**Re: NuVue I-40 and Wyoming
8526 Mountain Rd. NE
Traffic Circulation Layout
Engineer's/Architect's Stamp XX-XX-XX (J20-D028)**

Based upon the information provided in your submittal received 03-17-23, the above referenced plan cannot be approved for Building Permit until the following comments are addressed:

TRAFFIC CIRCULATION
PLAN

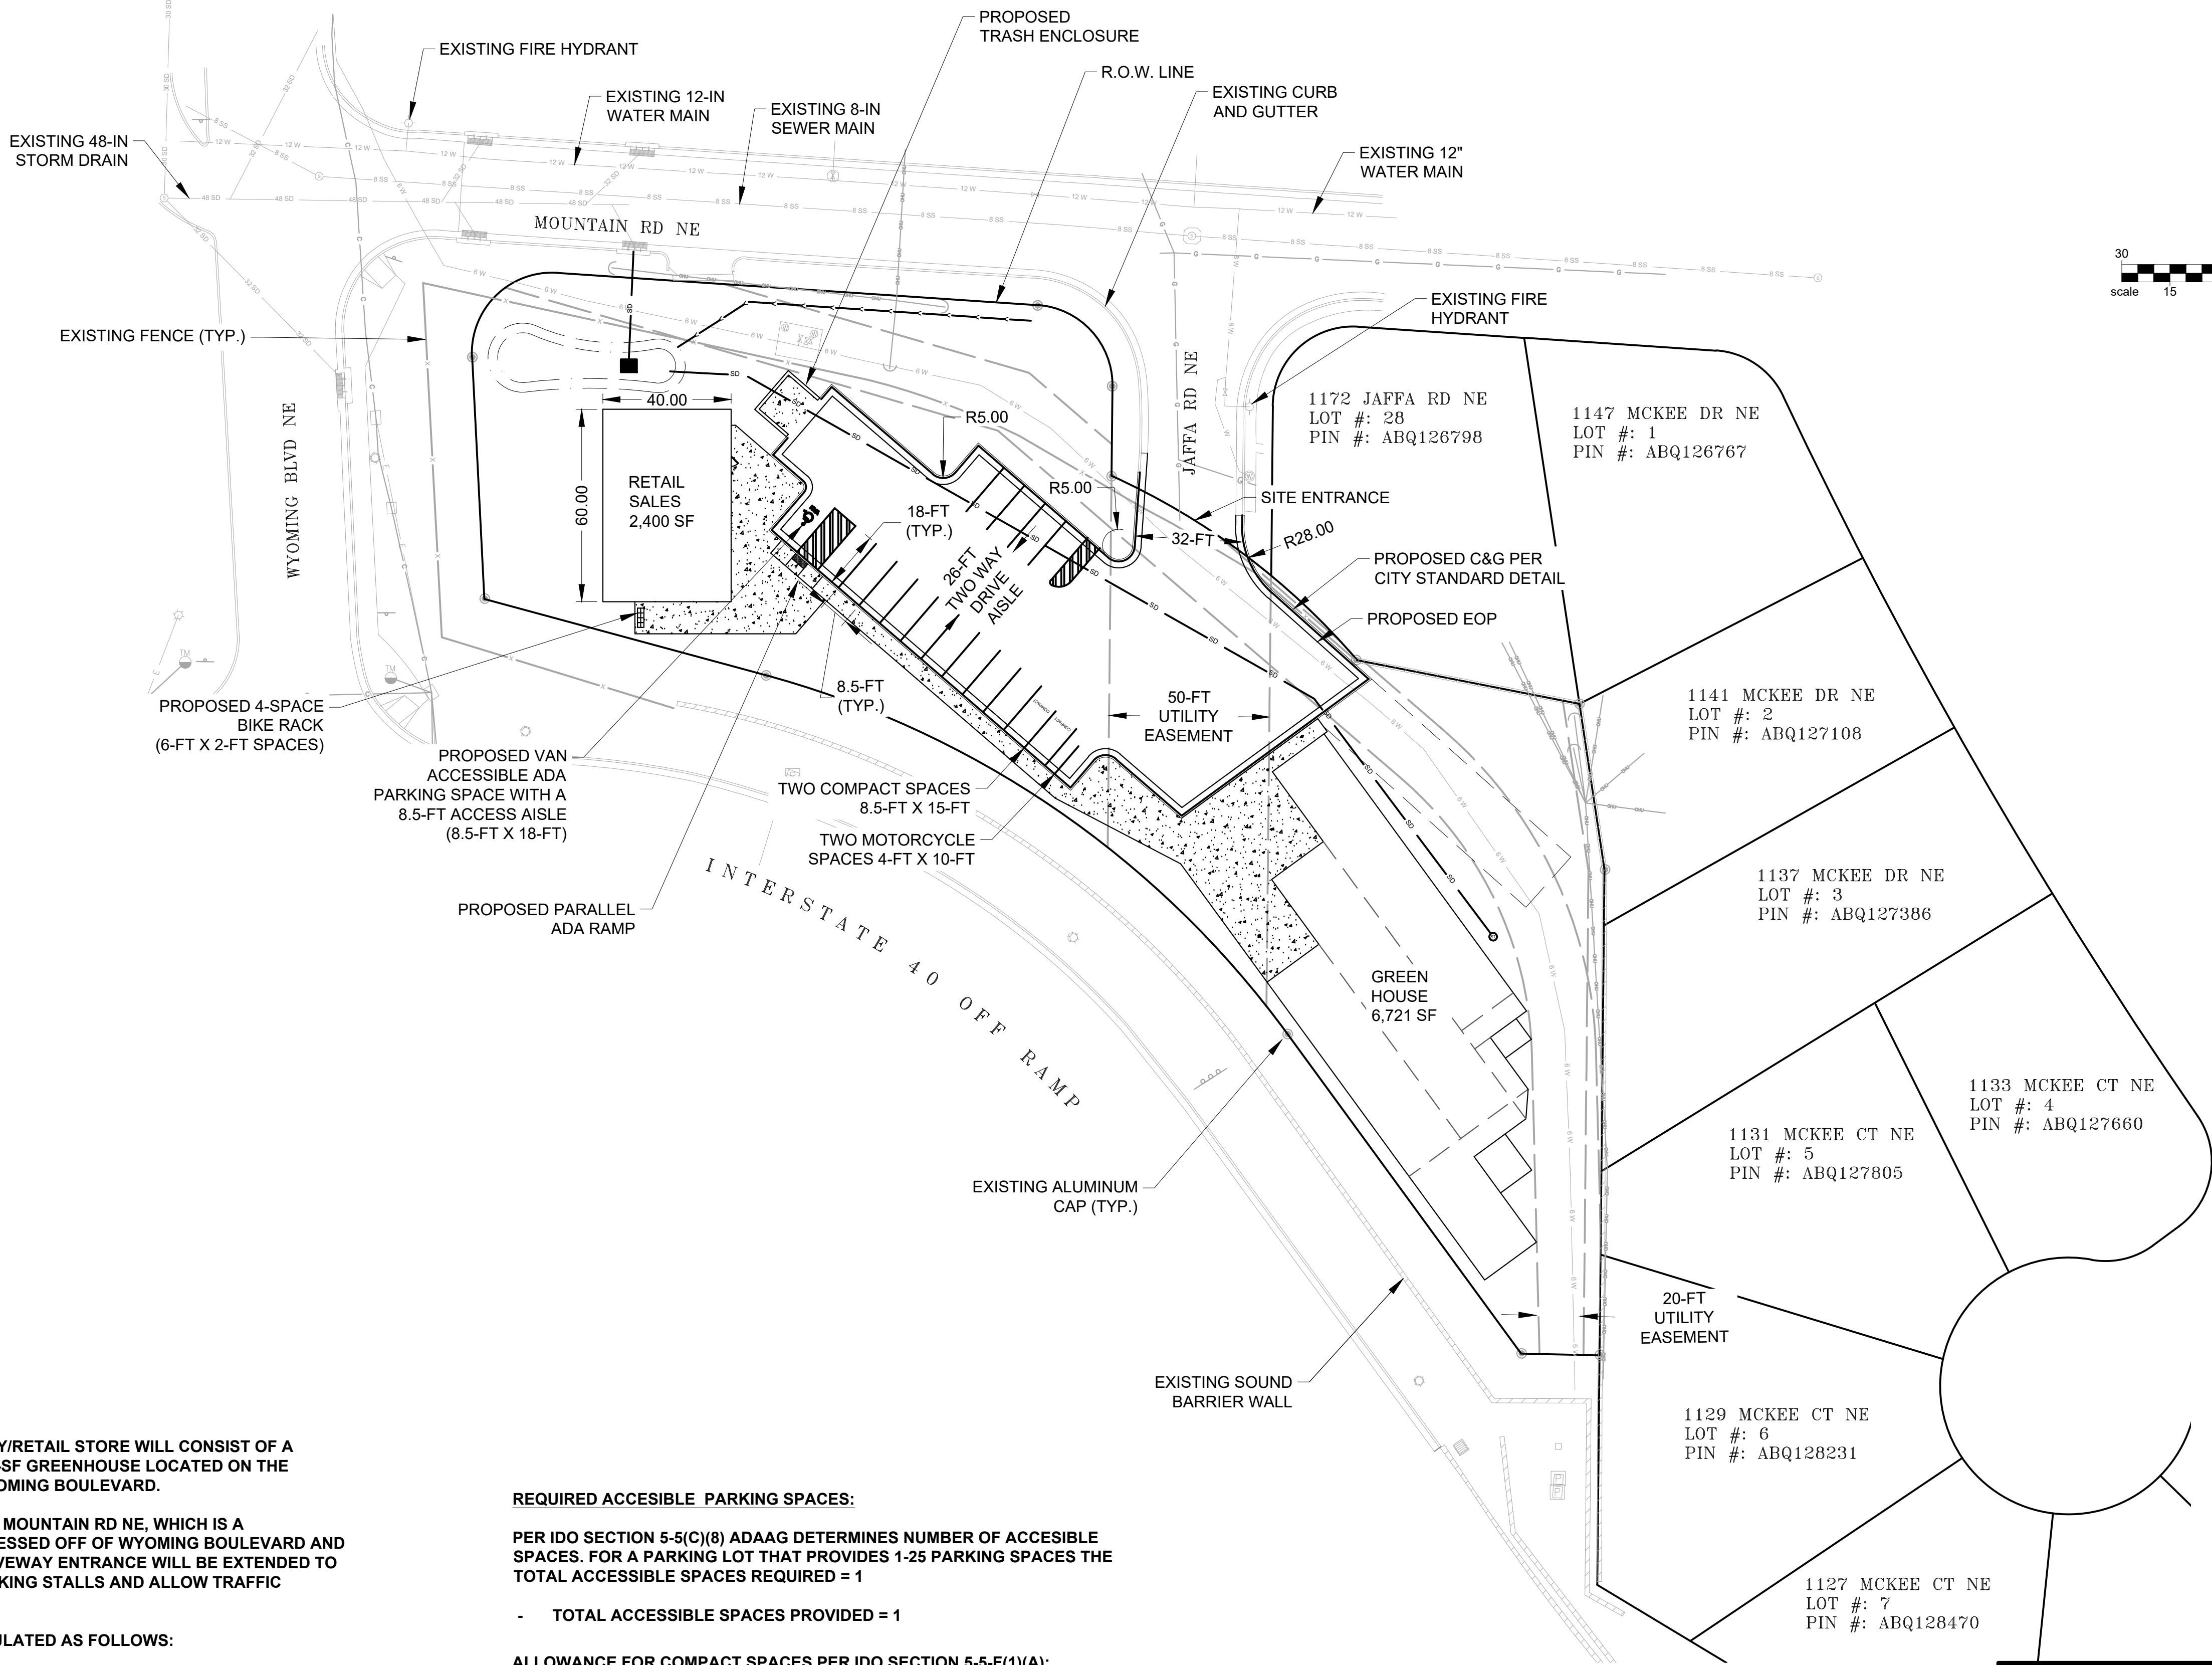
1. Please show a vicinity map showing the location of the development in relation to streets and well-known landmarks.
2. The traffic circulation layout must be stamped, signed, and dated by an engineer or architect licensed in the state of New Mexico.

3. Identify the right of way width, medians, curb cuts, and street widths on Wyoming Blvd. and Mountain Rd.
4. Please define the property line.
5. A 5 ft. sidewalk need to be built along Mountain Rd. from property line to property line. For sidewalk waiver, please contact Ernest Armijo earmijo@cabq.gov

6. Please remove the compact parking spaces because it's allowed when 20 or more parking spaces are provided.
7. Please provide details for all the proposed ADA ramp, signs, Bike Rack, and pavement marking.

8. The ADA accessible parking sign must have the required language per 66-7-352.4C NMSA 1978 **"Violators Are Subject to a Fine and/or Towing."** Please call out detail and location of signs.

9. The ADA access aisles shall have the words **"NO PARKING"** in capital letters, each of which shall be at least one foot high and at least two inches wide, placed at the rear of the parking space so as to be close to where an adjacent vehicle's rear tire would be placed. (66-1-4.1.B NMSA 1978)

10. ADA curb ramp at the corner of Wyoming and Mountain must be updated to current standards and have truncated domes installed.
11. Motorcycle parking spaces shall be designated by its own conspicuously posted upright sign, either free-standing or wall mounted per the zoning code.

12. The pavement marking "MC" should be shown in the opposite direction for Motorcycles entering the parking space.
13. All bicycle racks shall be designed according to the following guidelines:

14. Bicycle racks shall be sturdy and anchored to a concrete pad.
15. A 1-foot clear zone around the bicycle parking stall shall be provided.
16. Bicycle parking spaces shall be at least 6 feet long and 2 feet wide.

17. A 5 ft. keyway is required for dead-end parking aisles. Please show this dimension on the site plan.

18. Per the IDO, a 6 ft. wide ADA accessible pedestrian pathway is required from the public sidewalk to the building entrances. Please clearly show this pathway and provide details.

19. Per DPM, a 6 ft. wide ADA accessible pedestrian pathway is required from the ADA parking stall access aisles to the building entrances. Please clearly show this pathway and provide details.

20. ADA accessible pedestrian pathway should not be placed behind parking space or adjacent to a vehicular way. Vehicle and pedestrian/wheel chair conflicts should be avoided as much as possible.

21. Refuse vehicle maneuvering shall be contained on-site. The refuse vehicle shall not back into the public right of way.; provide a copy of refuse approval.

22. Provide a copy of Fire Marshal approval.
23. It is not apparent what type of pavement surface is being proposed. A hard driving surface will be required as part of this proposed project for parking area and drive aisles.

24. Show the clear sight triangle and add the following note to the plan: "Landscaping and signage will not interfere with clear sight requirements. Therefore, signs, walls, trees,

and shrubbery between 3 and 8 feet tall (as measured from the gutter pan) will not be acceptable in the clear sight triangle.
